TOWNSHIP OF VERONA BOARD OF ADJUSTMENT APPLICATION

Re: Zoning Permit # 2023-50

Zoning Request:

Zoning Decision:

BOARD OF ADJUSTMENT APPLICATION SITE PLAN

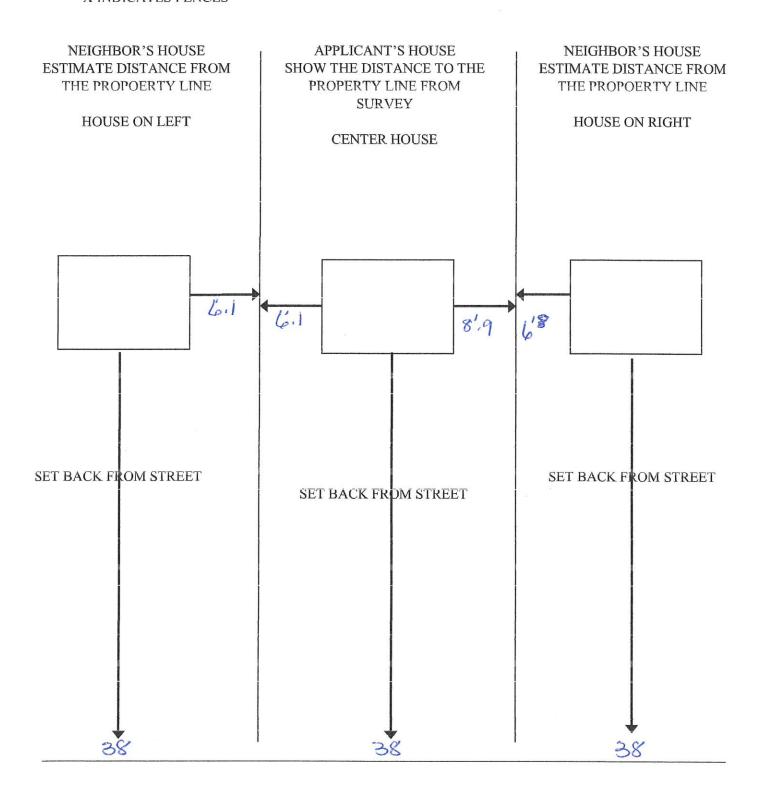
Based upon discussion with the applicant, the zoning permit application and the plan submitted, the owner is requesting zoning approval ONLY for the installation of two (2) new HVAC units within the side yard of the property. Although the marked up survey indicates other prior improvements, this submission is only for the two (2) HVAC units. No other requests have been considered in this review.

As per Sections 150-7.13 A and 150-17.4 E(2), the proposed AC units do not comply with the minimum side yard setback of 8 feet with a proposed setback of 2.5 feet and 3 feet. Therefore, a VARIANCE is required.

As per Sections 150-7.13 A, the proposed AC units are compliant to the maximum setback of 5 feet from the building with a proposed setback of approximately 0.8 feet.

The increase in impervious coverage is considered de minimis at 10.8 square feet,

Stormwater management is exempt since the increase in impervious is less than the 400 square foot threshold.

As noted on plan, no trees are proposed for removal.

Therefore, the applicants request(s) for zoning approval has been <u>**DENIED**</u> by this office. This application is deemed complete. Please coordinate with the Board of Adjustment Clerk for applying and scheduling this application before this Board.
